PRODUCT CHANGE NOTIFICATION

PCN No: PCN-1124

Issue Date: 7/7/2026

Reason for Change: Typographical error in the datasheet.

SECTION A-A

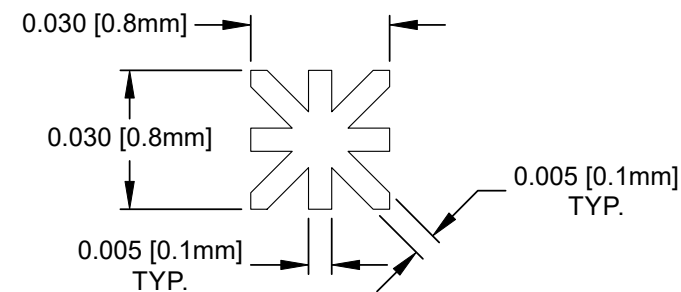
The 'DH' dimension for both LTM and NTM models with heights between 0.250 in and 0.290 in has been corrected from 0.185 (7.7 mm) to 0.185 (4.7 mm), as 7.7 mm was a typographical error.

REVISIONS			
REV.	DESCRIPTION	DATE	APPROVED
E	Changed LTM Material from 44-BK to 56-BK	06/27/07	M. C.
F	Updated Note 3.	09/24/13	T. Y.
G	Chg LTM Material to Halogen Free	11/20/19	A.V.
H	Chg LTM Material to 15%GF, ECO 1026	11/22/19	A.V.
J	ECO-1388 Fixed Dual Dimension Typo	06/09/26	A.V.

PART NO.	H	DH	PART NO.	H	DH	PART NO.	H	DH
LTM / NTM-120	.120(3.1)	.060(1.5)	LTM / NTM-300	.300(7.6)	.185(4.7)	LTM / NTM-490	.490(12.5)	.310(7.9)
LTM / NTM-130	.130(3.3)		LTM / NTM-310	.310(7.9)		LTM / NTM-500	.500(12.7)	.435(11.1)
LTM / NTM-140	.140(3.6)		LTM / NTM-320	.320(8.1)		LTM / NTM-520	.520(13.2)	
LTM / NTM-150	.150(3.8)		LTM / NTM-330	.330(8.4)		LTM / NTM-550	.550(14.0)	
LTM / NTM-160	.160(4.1)		LTM / NTM-340	.340(8.6)		LTM / NTM-570	.570(14.5)	
LTM / NTM-170	.170(4.3)		LTM / NTM-350	.350(8.9)		LTM / NTM-600	.600(15.2)	
LTM / NTM-180	.180(4.6)		LTM / NTM-360	.360(9.1)		LTM / NTM-620	.620(15.8)	.560(14.2)
LTM / NTM-190	.190(4.8)		LTM / NTM-370	.370(9.4)		LTM / NTM-650	.650(16.5)	
LTM / NTM-200	.200(5.1)		LTM / NTM-380	.380(9.7)		LTM / NTM-670	.670(17.0)	
LTM / NTM-210	.210(5.3)		LTM / NTM-390	.390(9.9)		LTM / NTM-700	.700(17.8)	
LTM / NTM-220	.220(5.6)	.185(4.7)	LTM / NTM-400	.400(10.2)	.310(7.9)	LTM / NTM-720	.720(18.3)	.690(17.5)
